***ADDENDUM 02***

***UPTON HASTINGS BATHROOM RENOVATION  
University of Southern Maine***

*Date: April 24, 2026*

AD101 HASTINGS HALL CORE BATHROOM PART PLANS, ELEVATIONS, AND DETAILS:

**USM ANDERSON HALL AND UPTON-HASTINGS SHOWER RENOVATIONS  
01 14 00 WORK RESTRICTIONS SITE PLAN**

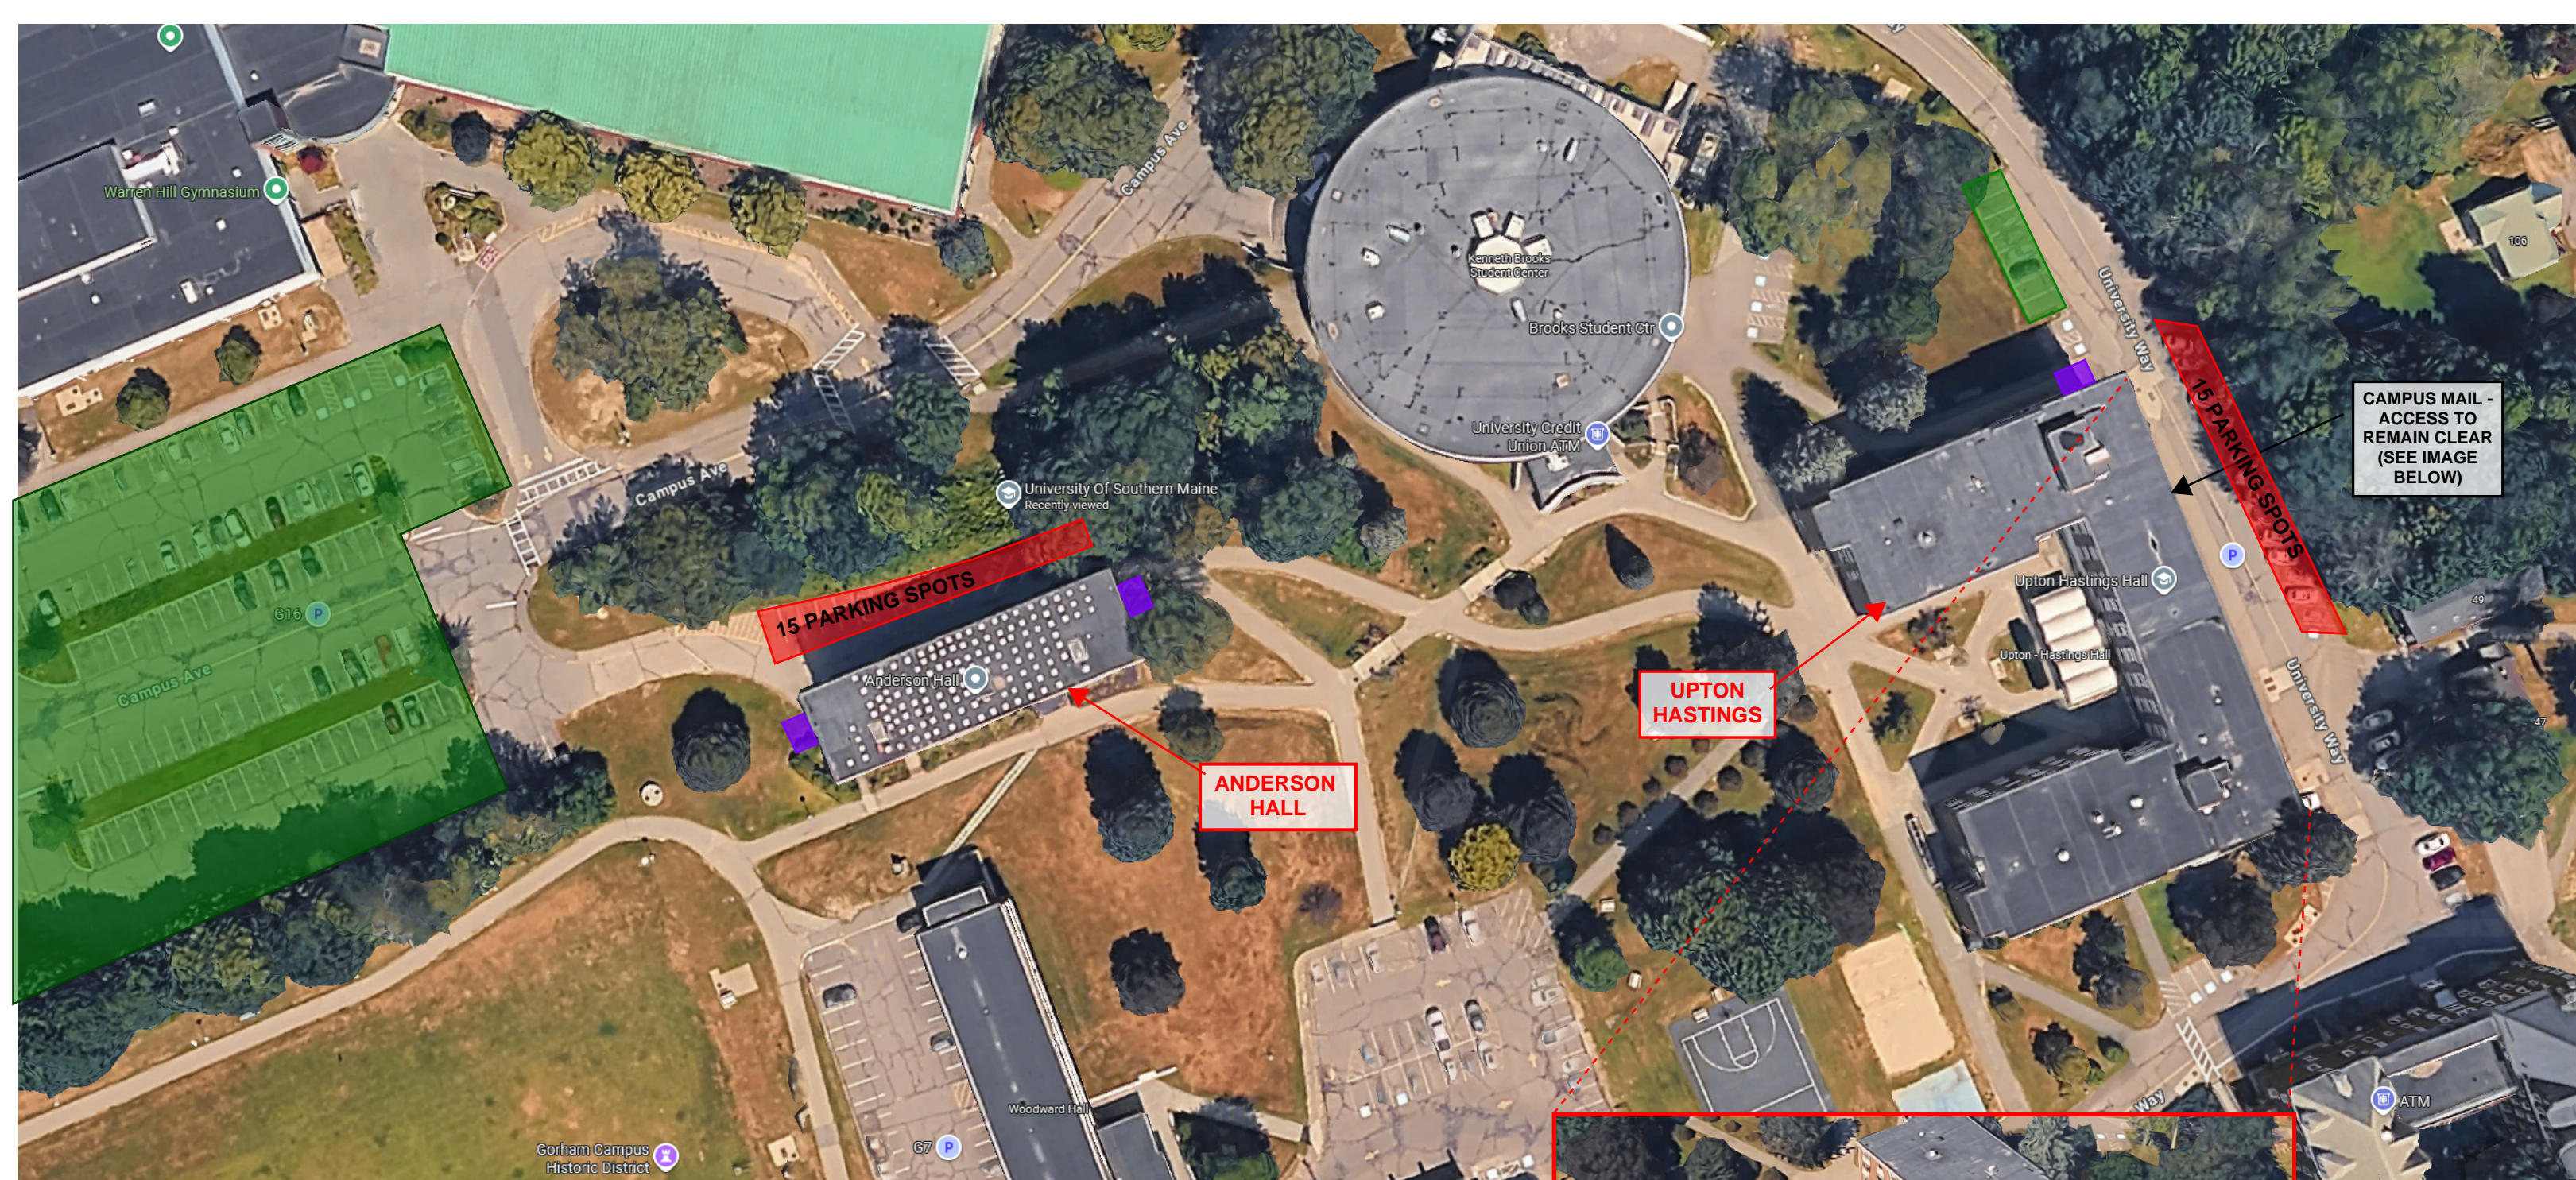
**ADD** Section 1.01, "G, Site Plan: See attachment "01 14 00 Work Restrictions Site Plan" for parking information, laydown area, and dumpster/trash chute locations."

G. Site Plan: See attachment "01 14 00 Work Restrictions Site Plan" for parking information, laydown area, and dumpster/trash chute locations.

**3 HASTINGS HALL CORE BATHROOM 277 REMOVALS REFLECTED CEILING PART PLAN**  
AD101 SCALE: 1/4"=1'-0" (BATHROOMS 377, 476 SIM)

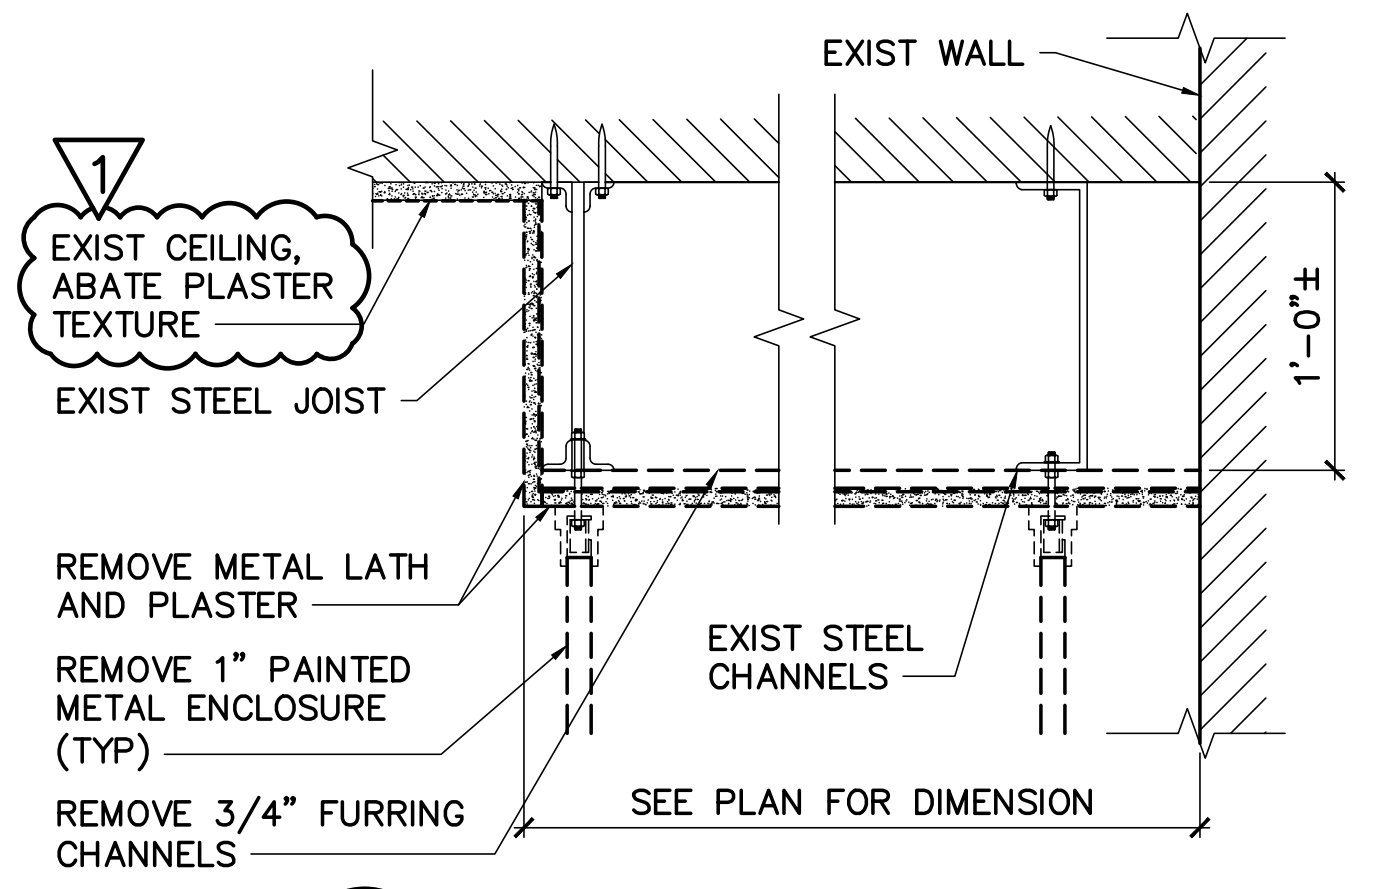
**ADD** Keynote 5 for ceiling texture abatement (Bathroom 277 only) and add dimensions to reflected ceiling plan.

- ① REMOVE 1" PAINTED METAL ENCLOSURE (TYP).
- ② REMOVE CURTAIN RODS AND CURTAIN (TYP).
- ③ REMOVE 10" DEEP BENCH AND SUPPORT (TYP).
- ④ REMOVE PLASTER SOFFIT.
- ⑤ ABATE ASBESTOS CONTAINING PLASTER CEILING TEXTURE. SAND AND PREP FOR PAINT. (BATHROOM 277 ONLY)

**3 HASTINGS HALL CORE BATHROOM 277 REFLECTED CEILING PART PLAN**  
AE101 SCALE: 1/4"=1'-0" (BATHROOMS 377, 476 SIM)

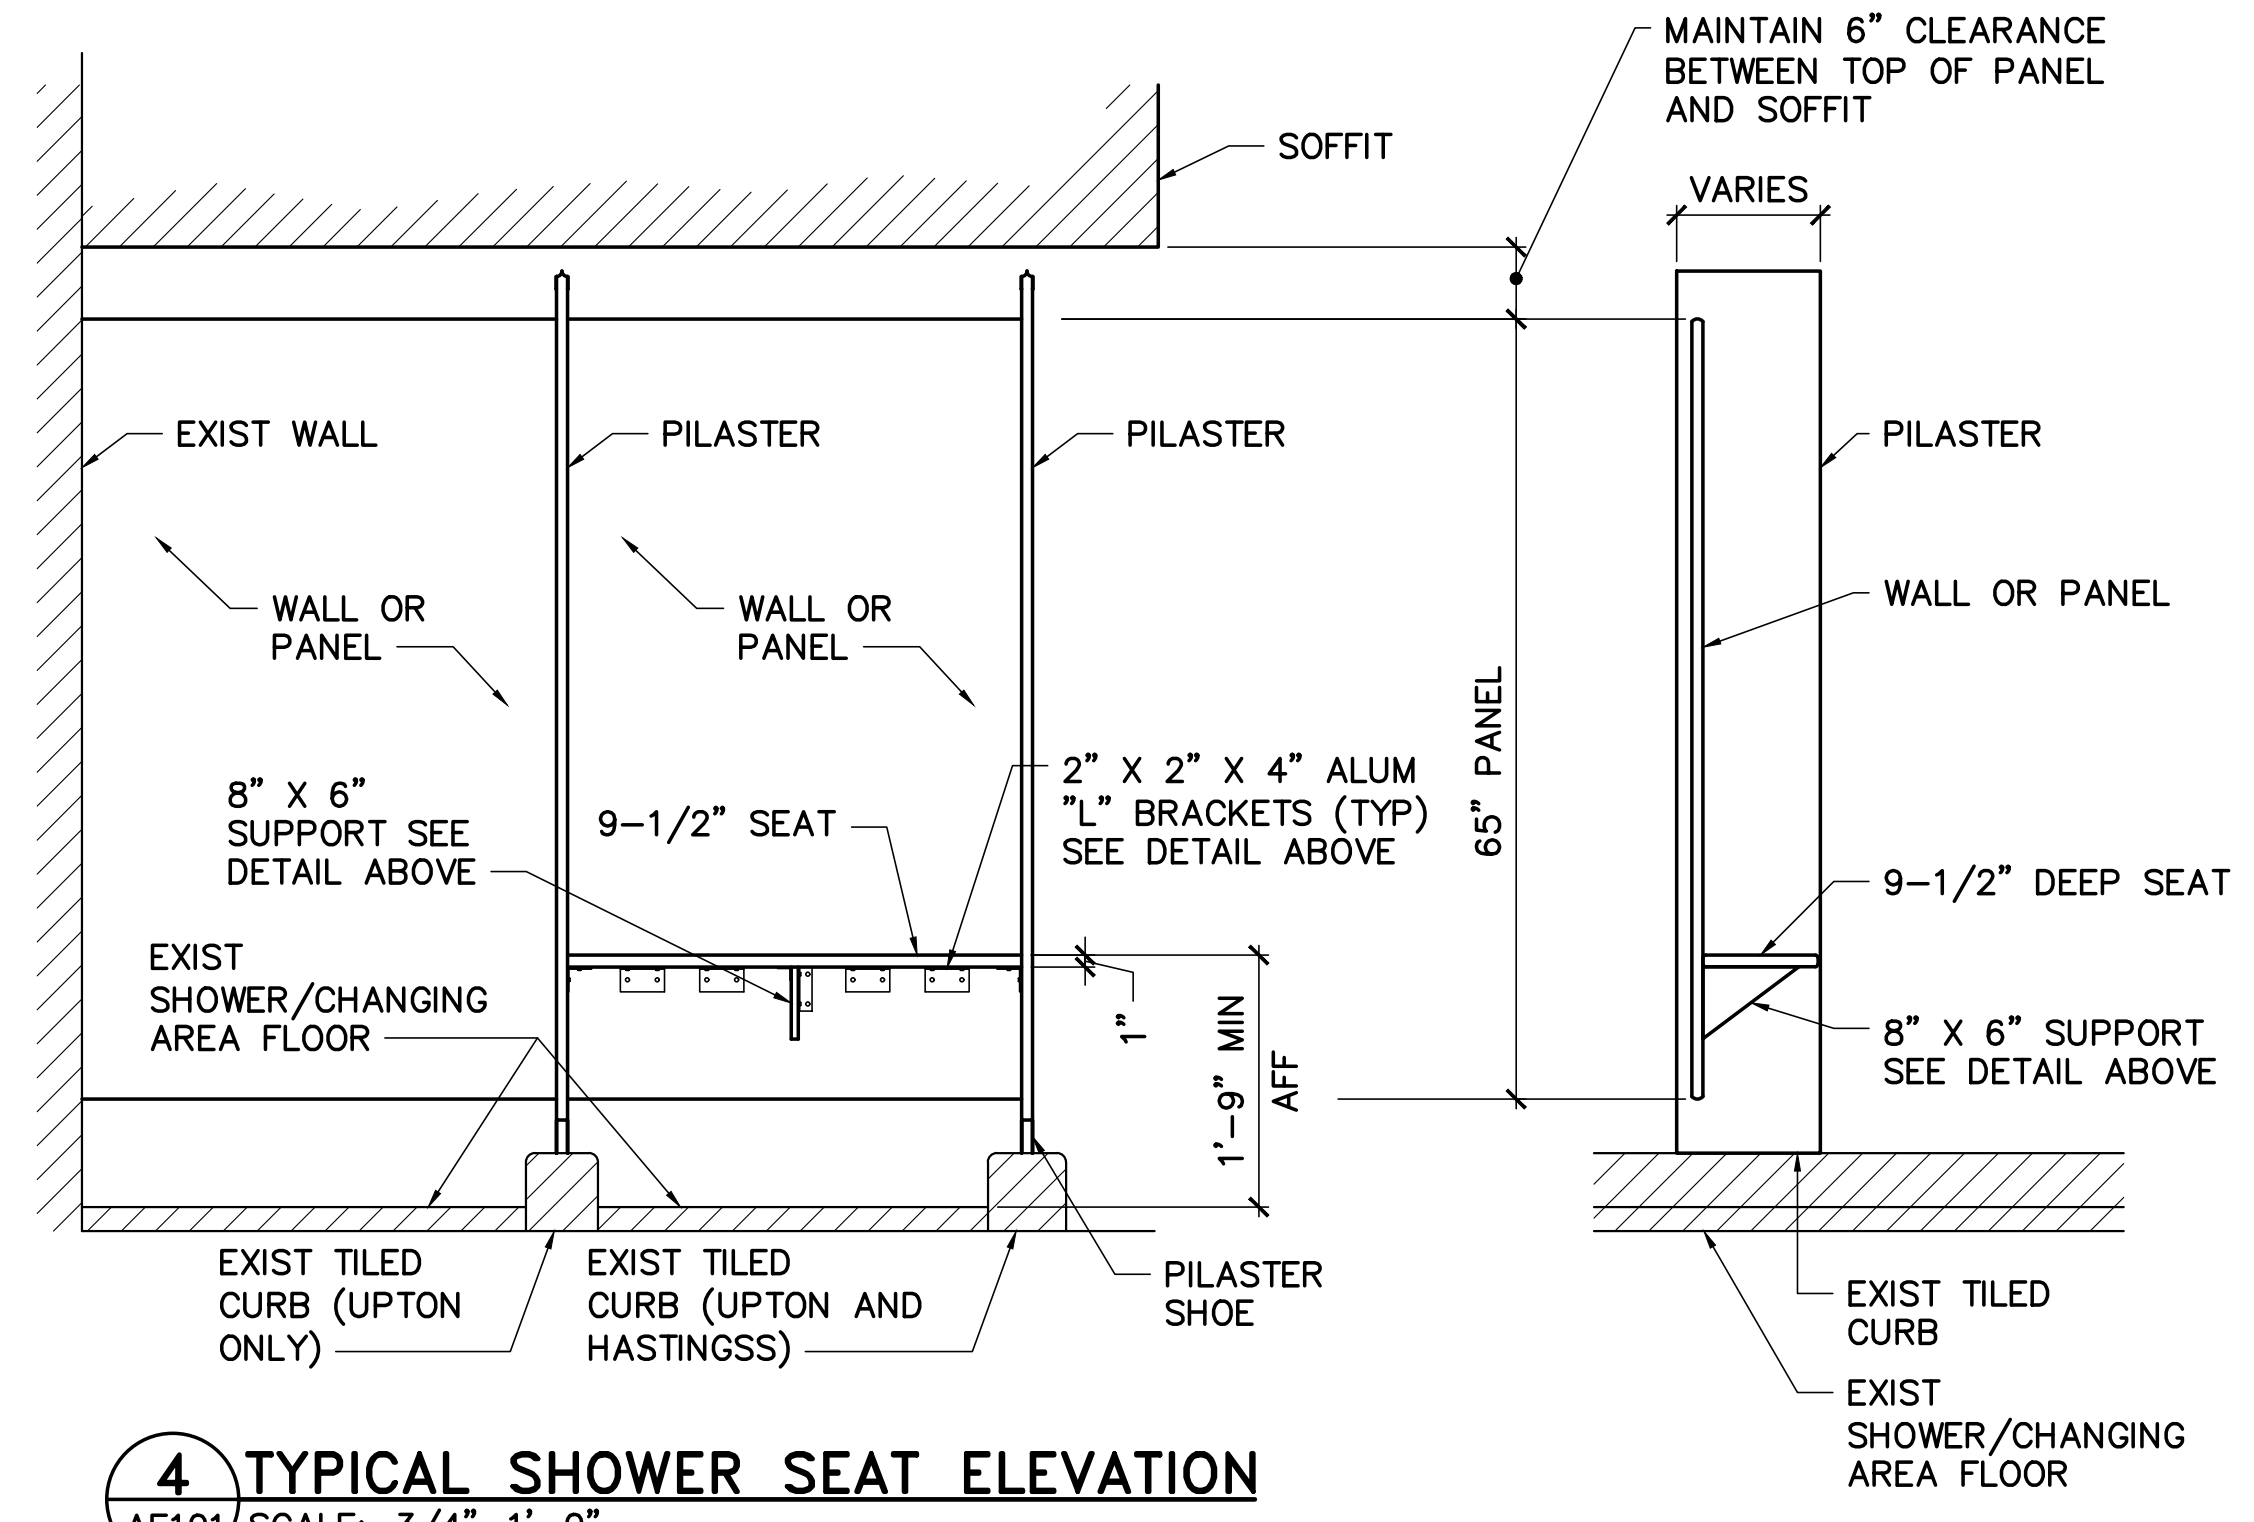
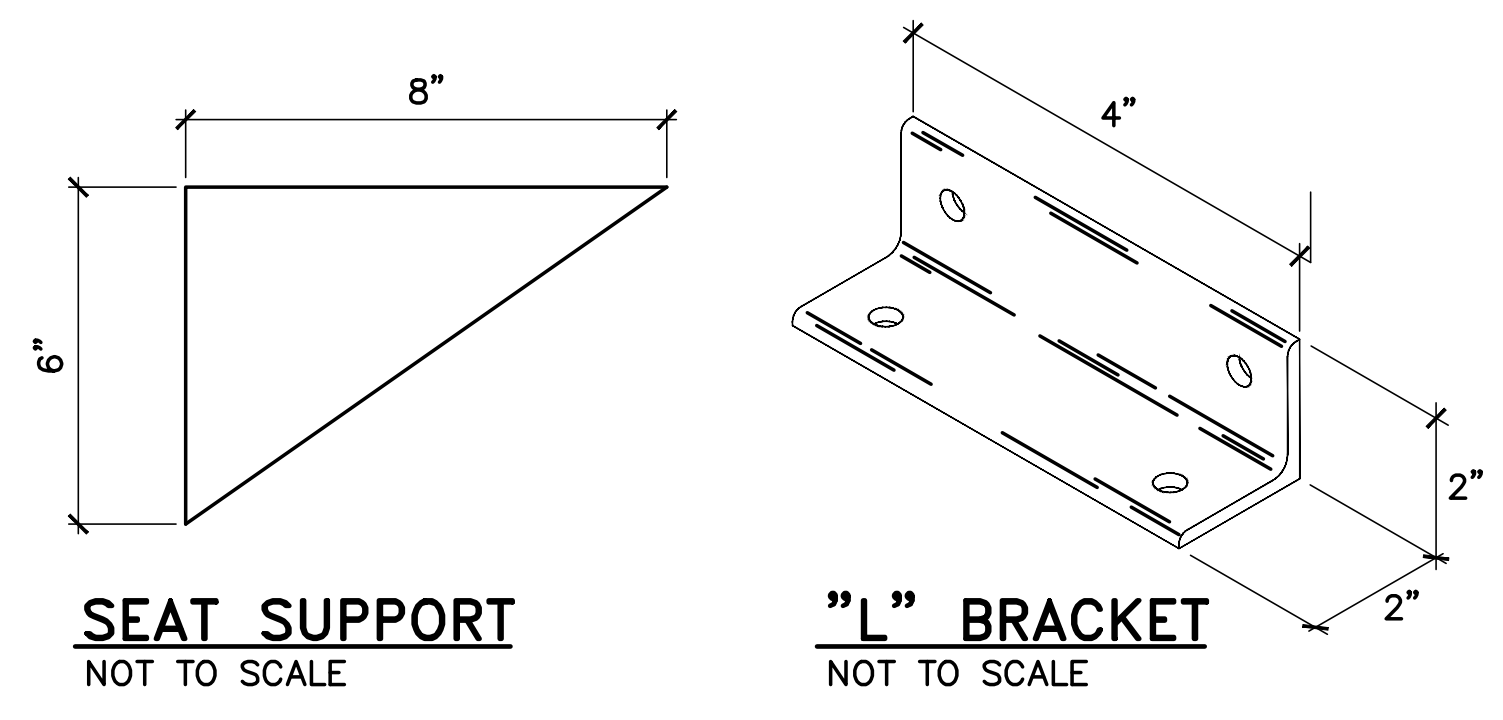
**ADD** Keynote 5 for ceiling paint (Bathroom 277 only) and add dimensions to reflected ceiling plan.

- 1 FLOOR MOUNTED OVERHEAD BRACED HDPE SHOWER PARTITION (TYP). RETAIN TOP OF PANELS 6" FROM BOTTOM OF SOFFIT.
- 2 HEADRAIL W/SHOWER CURTAIN (TYP).
- 3 PARTITION SUPPORTED BENCH (TYP). SEE DETAIL 4/AE101.
- 4 SOFFIT, PNT.
- 5 ABATED CEILING, PNT. (BATHROOM 277 ONLY)
